1. January 7, 2025 HPC Meeting Agenda And Packet

City of Excelsior
Notice of Special Meeting
of the Excelsior Heritage Preservation Commission

City of Excelsior
Special Meeting Agenda
Excelsior Heritage Preservation Commission

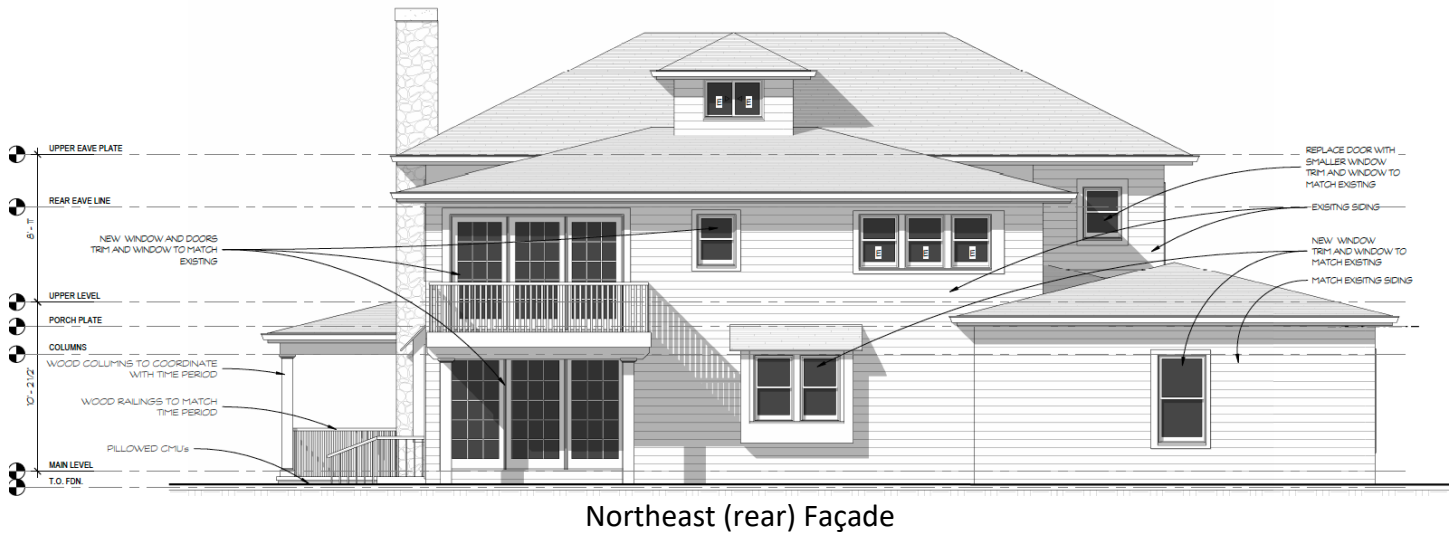
Design Manual at 62 (emphasis added). In addition, Standard No. 6 of the Secretary of the Interior’s Standards provides that:

Where the severity of deterioration requires replacement of a distinctive feature, the new feature shall match the old design, color, texture, and other visual qualities and where possible, materials.

Secretary of the Interior’s Standards #6 (in the Design Manual at page 5). Accordingly, it is not surprising that, at the hearing before the HPC, one of the longest serving commissioners said that he could not recall a time when the commission had approved aluminum clad windows on a facade that is visible from the street. It is also worth noting that the commission required the owner of 262 Lake Street to use only wood windows for replacement on the front and front-most sides of the house at the same meeting where one of the Applicants’ applications was considered.

Condition 1: Precedent allows wood clad windows where original windows are missing

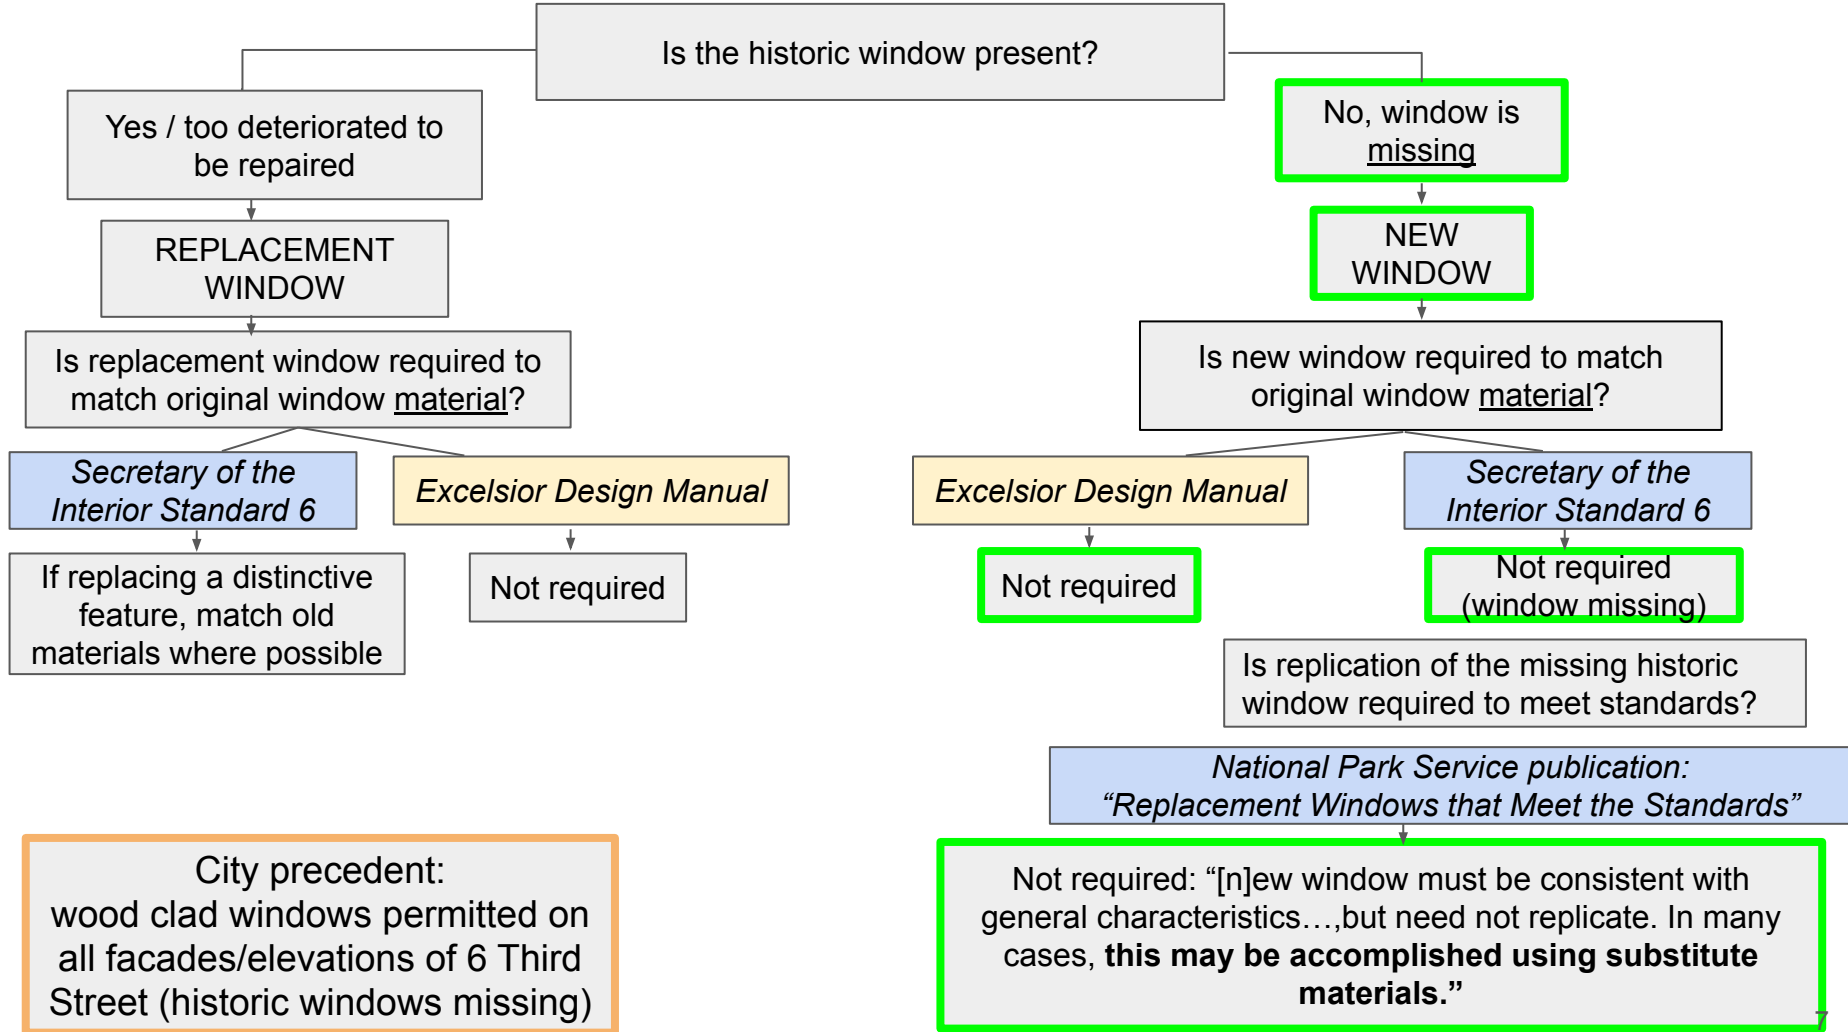
The city's past precedent likewise demonstrates that wood clad windows are permitted under the Guidelines in the context of new windows where historic windows are missing:

Wood clad windows were permitted on all facades of the Landmark structure at 6 Third Street (historic windows were missing).

Recently approved addition to Landmark property with new design elements not historically present

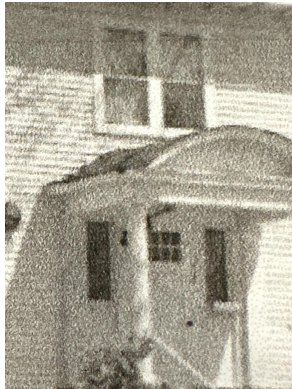
No false history. The risk of creating a false history is minimal, as the existing non-historic addition is clearly distinguishable from the original structure in height, soffit detailing, and size/pattern of window and door openings. Square divided lights are also frequently used in new, modern construction projects and are not exclusively associated with a narrowly defined period of years.

Proposed windows are on non-historic addition and located at the rear and far back corner of a secondary elevation of such addition. The proposed windows are minimally visible from the street and are located more than 80 feet from the front property line. Allowing the proposed divided lights on the non-historic addition in this minimally visible location will not damage the historic character of the home.
